REMARKS

This amendment is responsive to the office action dated January 27, 2005. Claims 1, 3, 5, 7, 9, 11, 13, 15, 17, 19, 21, 23, 25, 27, 29, 33, 39, 41 and 45 have been rejected. Claims 31, 35, 37, 43 and 47-53 are withdrawn from consideration. Reexamination is respectfully requested in light of the following amendments in the specification, drawings and claims.

Snider & Associates Ronald R. Snider P.O. Box 27613 Washington, D.C. 20038-7613 Tel. (202) 347-2600 AMENDMENTS TO THE DRAWINGS:

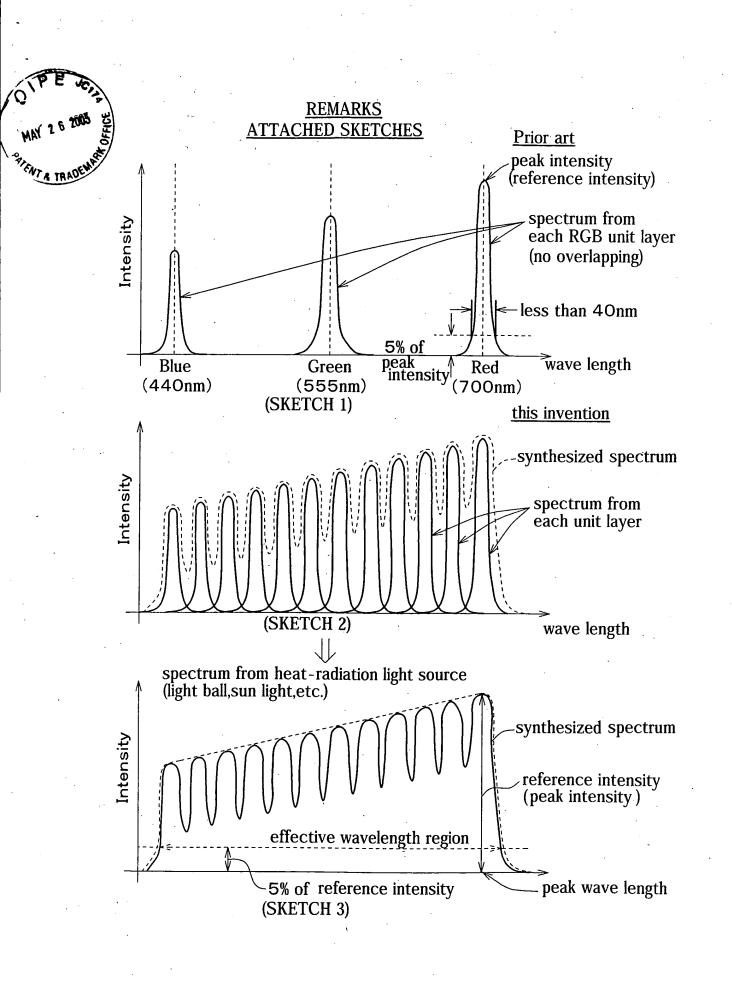
Reference numerals 11, 21, 71, 151 and 174 in Figs. 22, 24 and 25, which were pointed out as being not described in the detailed description, were deleted.

Reference numerals 10 and 20 for the light emitting devices were added to Fig. 22 and Fig. 25.

In Figure 22, the reference numbers "10" and "20" have been added and the

reference numbers "71" and "174" have been deleted.

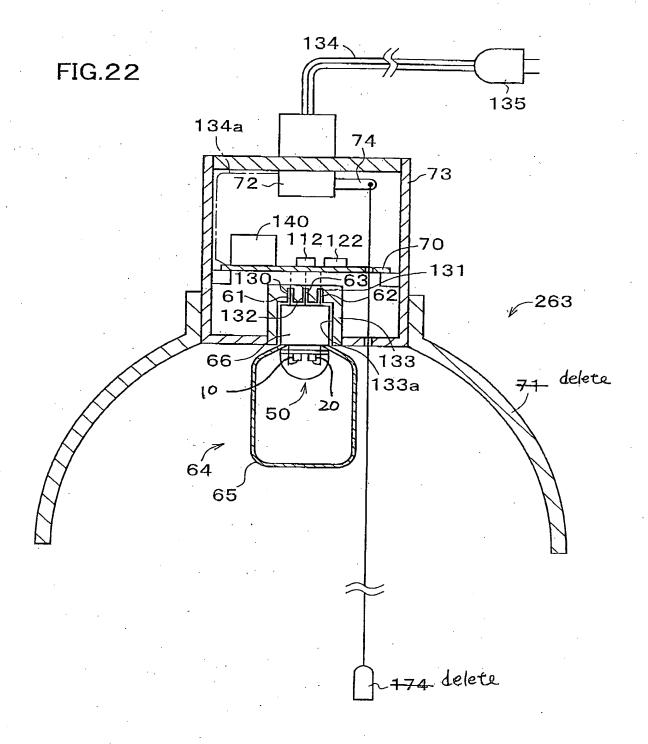
In Figure 23, the reference numbers "11" and "21" have been deleted.

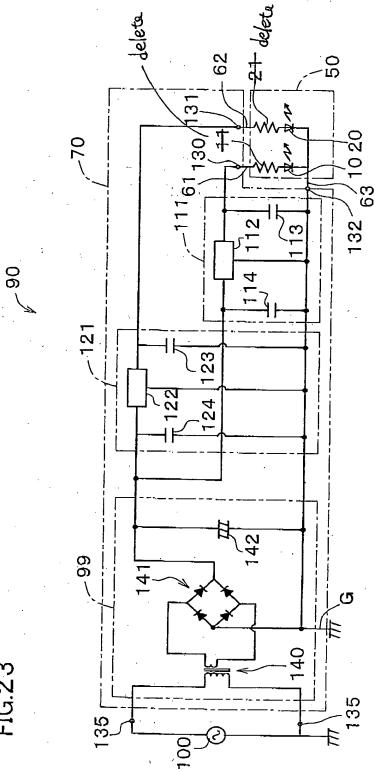
It is to be noted that "12107531" found in Fig. 24 is an IC terminal number indicated on a package of BP5057-15, product of Rohm Co., Ltd, JAPAN, cited as an example of a power source IC102 in this patent specification, and is not a reference numeral.

Reference numeral 30 in Fig. 24 was erroneous, and was corrected to 50.

In Figure 24, the reference number "30" has been changed to "50".

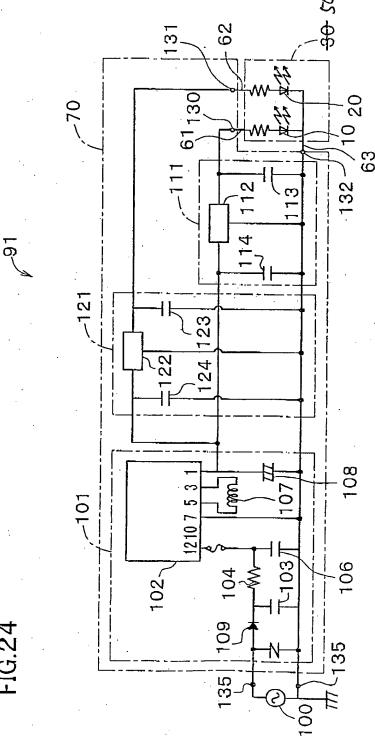
In Figure 25, the reference numbers "10" and "20" have been added and the

reference numbers "89" and "151" have been deleted.

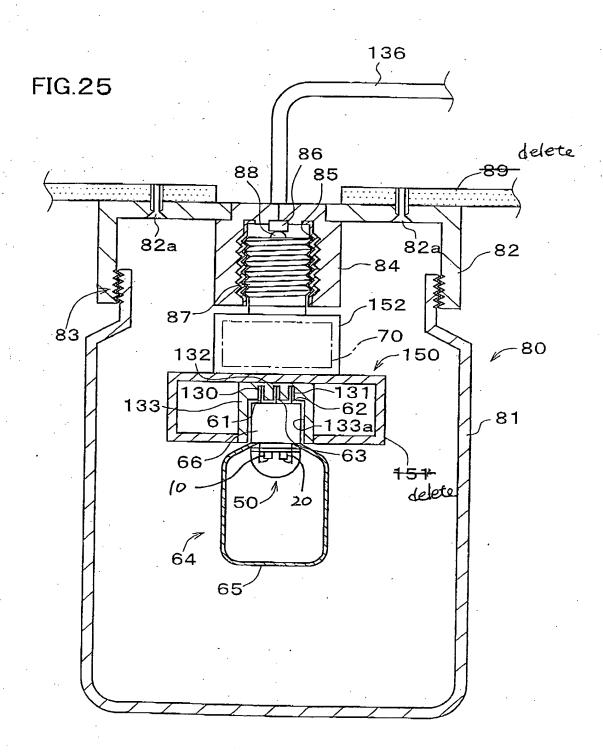
In Figure 26, the reference number "89" has been deleted.

FIG.33

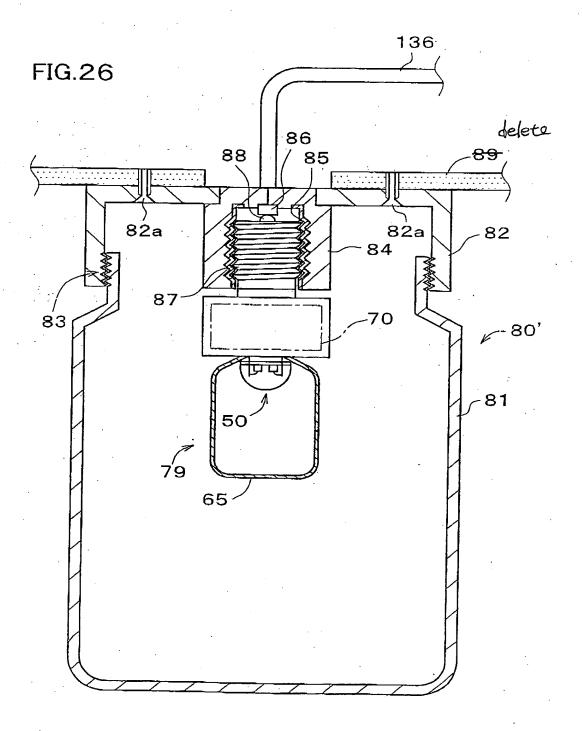
In Figure 33, the reference number "62" has been changed to "63"
